Work Order ID 159494

Item ID: D205-596-105 Accept ***N900040100*** Setup Start ***NS1***
Revision ID: URF 14-644 Stop ***NS2***
Item Name: Fwd Crosstube - Extended Height 31"
Start Date: 5/1/2017 Start Qty: 1.00 ***1*** Cust Item ID:
Required Date: 5/9/2017 Req'd Qty: 1.00 ***1*** Customer:
Reference: SCHEDULED/S

DART AEROSPACE LTD		Work Order:	159494
Description: Crosstube High-High Fwd		Part Number:	D205-596-105
Inspection Dwg: D205-596-105 Rev: B		Page 1 of 1

DRAWING NO. D205-596-105	TITLE CROSSTUBE ASS'Y, HI-HI FWD	REV. B	DART AEROSPACE LTD ENGINEERING ORDER		D.E.O. NO. D205-596-105-B-2	SHEET NO. SHEET 1 OF 1	SCALE NTS
DRAWN <i>qp</i>	CHECKED <i>A.P.</i>	MFG. APPR. <i>AS</i>	APPROVED <i>MP</i>		DE APPR. <i>MP</i>		
DATE 13.11.11	DATE 13.11.19	DATE 13.11.19	DATE 13/11/21		DATE 13/11/21

FIGURE 1 - SUPPORT INSTALLATION

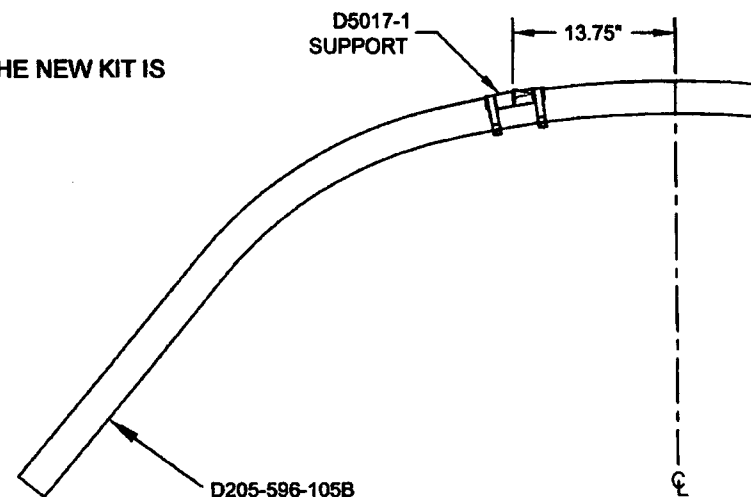
ADD THE FOLLOWING CROSSTUBE ASSEMBLY:

Qty	Part Number	Description
X	D205-596-105B	CROSSTUBE ASSEMBLY (214 HI-HI FWD)

THE D205-596-105B CROSSTUBE HAS THE SAME PARTS LIST AS THE D205-596-105 CROSSTUBE EXCEPT AS FOLLOWS:

INSTALL THE SUPPORTS AS SHOWN IN FIGURE 1 OF THIS ENGINEERING ORDER. THE NEW KIT IS OTHERWISE ASSEMBLED PER THE D205-596-105 CROSSTUBE.

IS:

2	D5017-1	SUPPORT
---	---------	---------

WAS:

2	D2893-1	SUPPORT
---	---------	---------
